Lower Thames Crossing TR010032

Responses to ExQ1 submission

Thames Crossing Action Group

DEADLINE 4 (19th September 2023) / Submitted 19th September

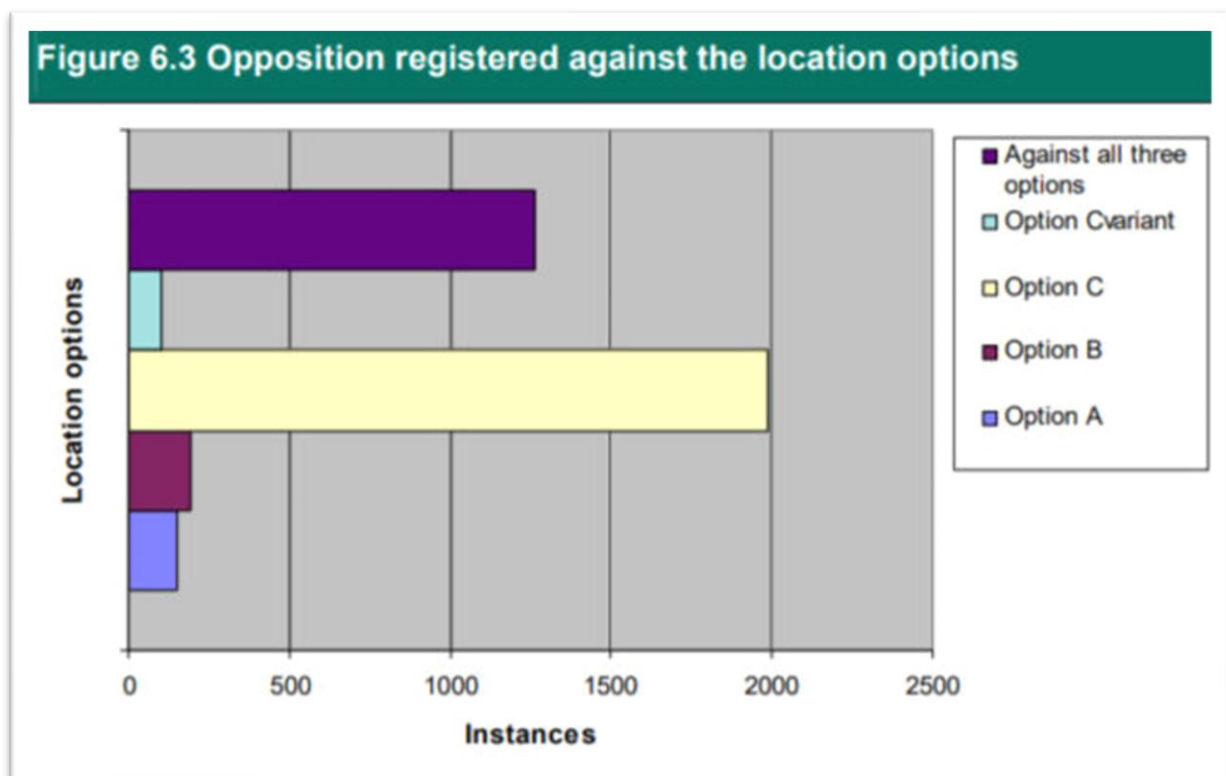
63. Most interesting to us is the fact that on Page 31 it clearly states in point 9.3

*“Again, we received a mixed reaction regarding the location options, with **20% of all respondents expressing a preference for a new crossing at location Option A**, 5% preferring Option B, **17% preferring either Option C or C variant**, and 26% expressing a preference for another location. **Option A was preferred by most individual respondents and Options C and C variant were most popular with those responding on behalf of organisations.**”*

64. Remember, location Option A covered many variants around a similar location to the current Dartford Crossing, location Option C had many variants all in a similar location to what is now the proposed LTC then known as Option C3. They clearly state that ***“Option A was preferred by most individual respondents and Options C and C variant were most popular with those responding on behalf of organisations”***(most likely businesses).

65. So, this tells us that as far back as 2013 the most favoured location option overall was the residents choice of location Option A, and one of the least favoured was location Option C.

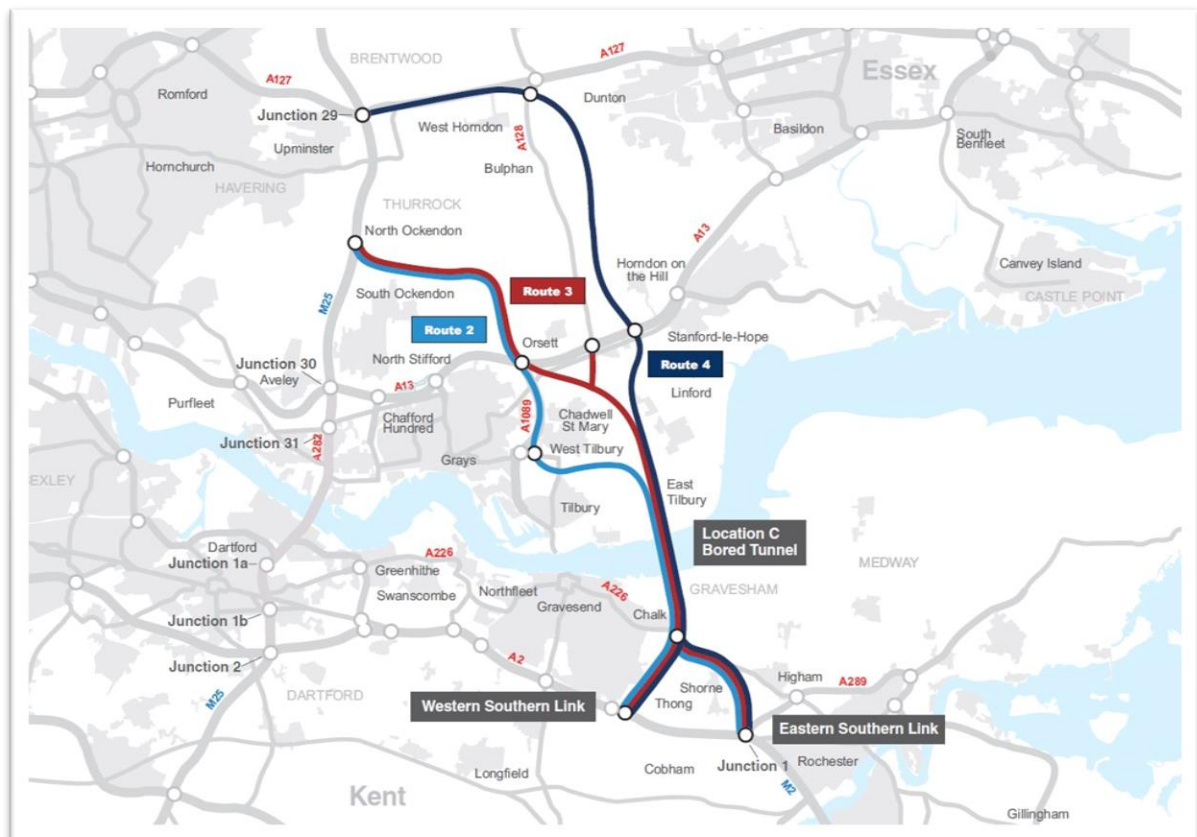
72. We draw attention to the fact that the map they present includes Route 1, yet please note the image we shared above it taken from the 2016 consultation that does not include Route 1.
73. Please also note similarly that the 2016 consultation questionnaire also featured a map on the front that didn't include Route 1, as can be seen in the capture below (and in the additionally submitted 2016 LTC Consultation Questionnaire document)

74. This can be seen highlighted within the circle marked 1. Additionally, we note that Highways England (as they were known then) did not send enough consultation booklets to the borough, and Thurrock council made multiple formal complaints during the consultation and requested more booklets. Most arrived after the consultation finished.

Plate 3.3 The preferred route announced in April 2017

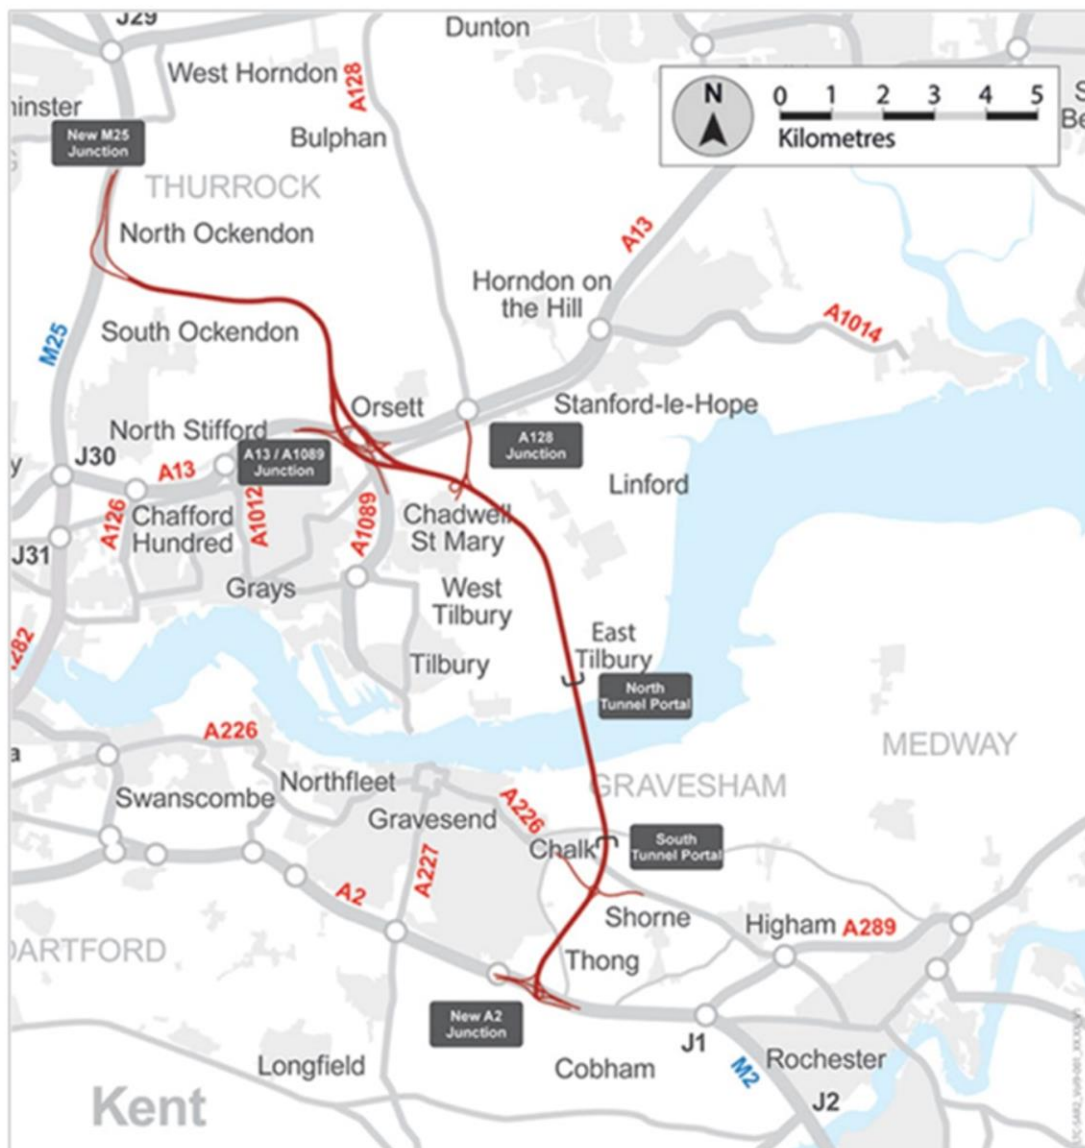
90. We have to question whether the same decision would be made now in light of how much has changed both in regard to the proposed route, and what the world looks like now.
91. We do not feel that there has been adequate consideration or consultation, and definitely do not believe that an adequate reassessment on the route selection has been carried out. We believe that if the decision was made again now, knowing what we now know and with the project as it is being proposed, the LTC would not have been chosen.

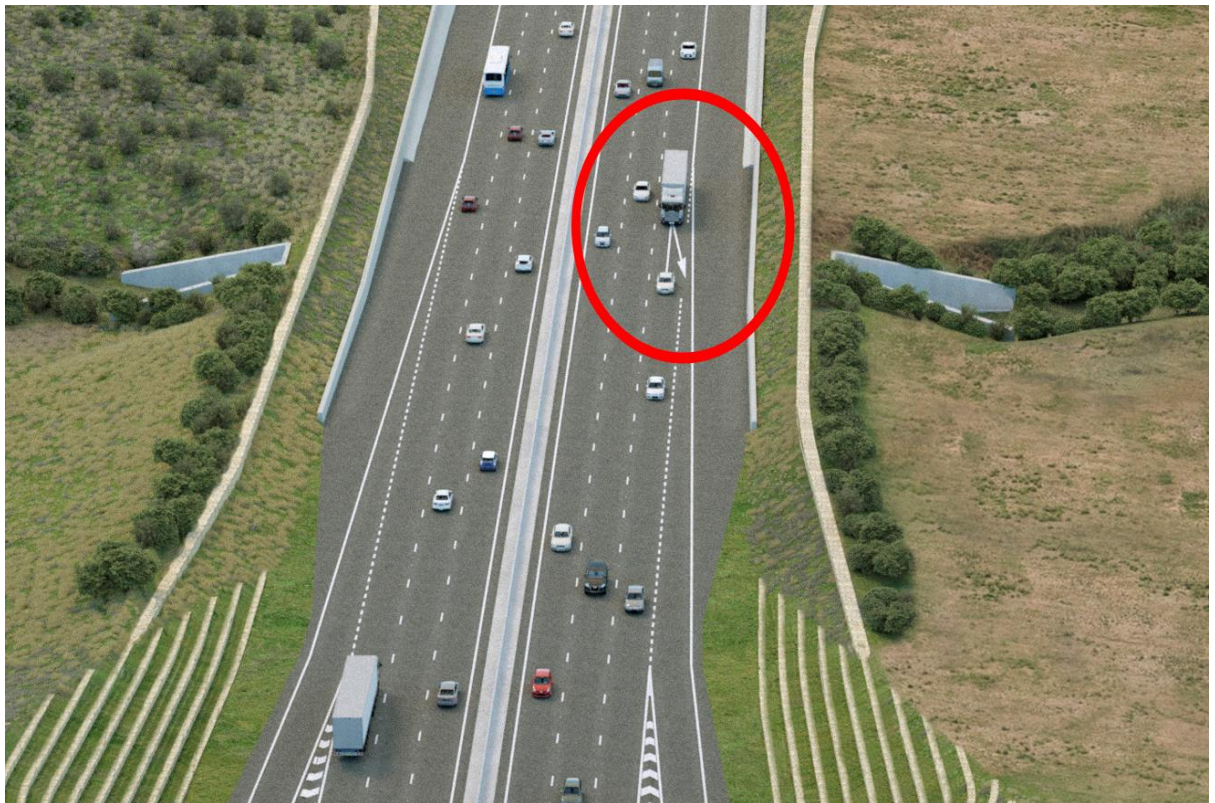
131. We ask if we are really supposed to believe that there would be no PM2.5 pollution to watercourses if the proposed LTC goes ahead?
